HISTORIC AND DESIGN REVIEW COMMISSION

July 17, 2019

HDRC CASE NO: 2019-363
ADDRESS: 405 GILLESPIE
LEGAL DESCRIPTION: NCB 1745 BLK 8 LOT S 51.5 FT OF N 103 FT OF 5 E IRR 7FT OF MID PART OF 5 & 6
ZONING: R-6
CITY COUNCIL DIST.: 1
DISTRICT: Tobin Hill Historic District
APPLICANT: Jake Forshpan/FORSHPAN JAKE B & FORSHPAN SHARON K
OWNER: Jake Forshpan/FORSHPAN JAKE B & FORSHPAN SHARON K
TYPE OF WORK: Modifications to side porch
APPLICATION RECEIVED: June 26, 2019
60-DAY REVIEW: August 25, 2019
CASE MANAGER: Huy Pham

405 Gillespie St
San Antonio, Texas

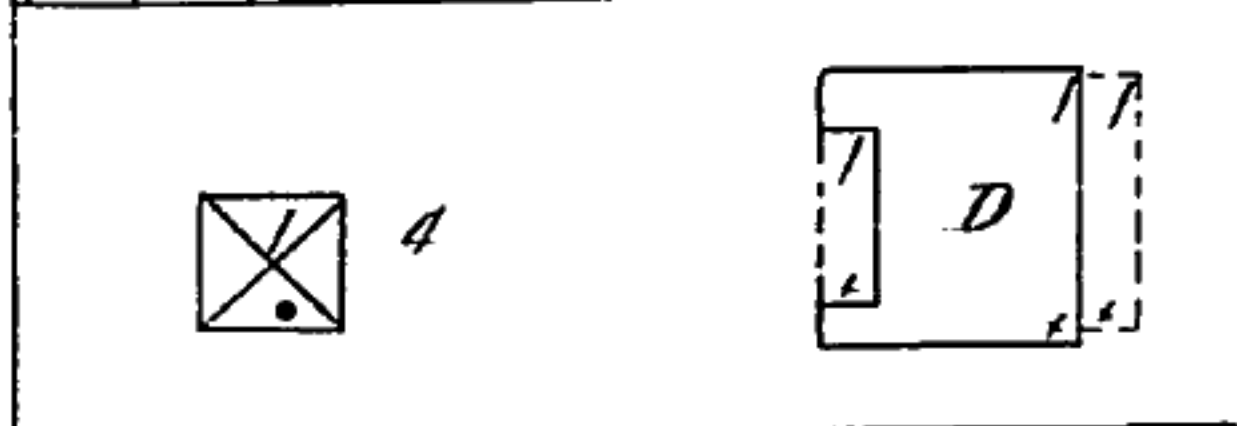
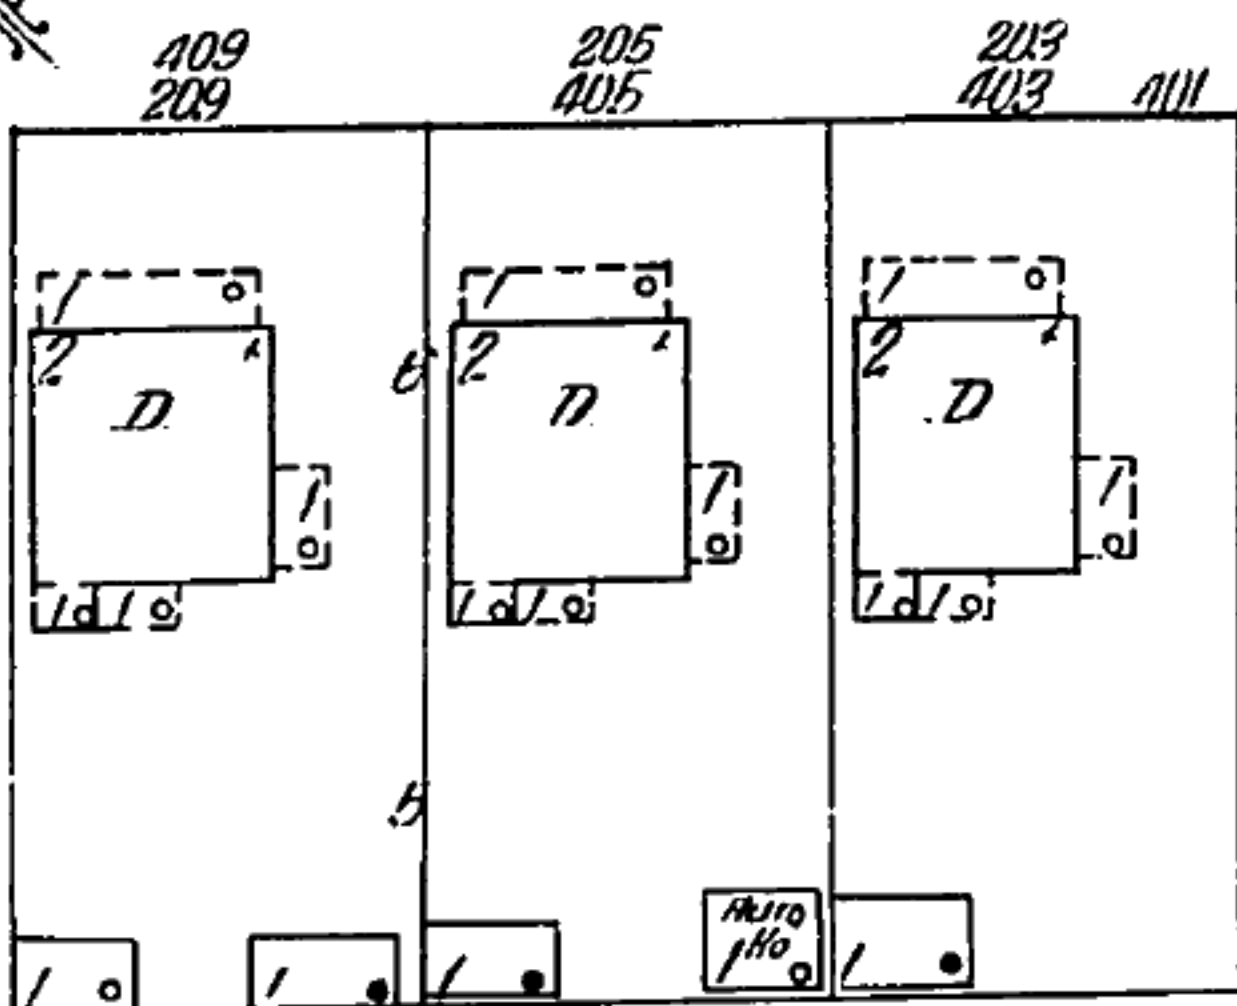
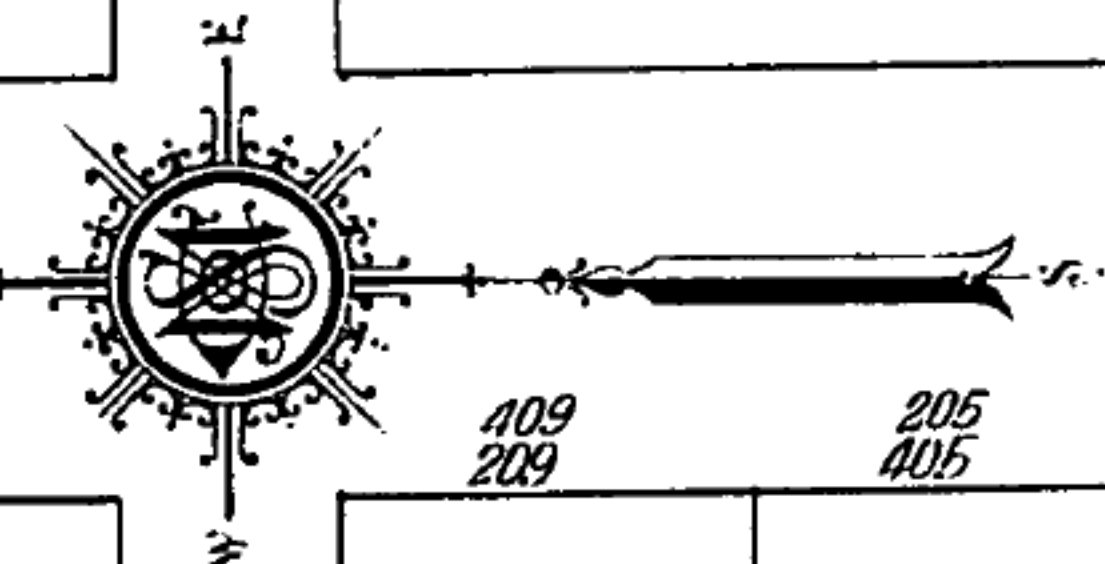
RECONSTRUCTION TO MATCH THIS PHOTO.

MEASURED DRAWINGS IN REAR WALL PLANE SETBACK AND FIRST FLOOR ENCLOSURE DETAILS MATCHING REQUEST AND APPROVAL LANGUAGE MUST BE SUBMITTED TO STAFF PRIOR TO THE ISSUANCE OF A CERTIFICATE OF APPROPRIATENESS.
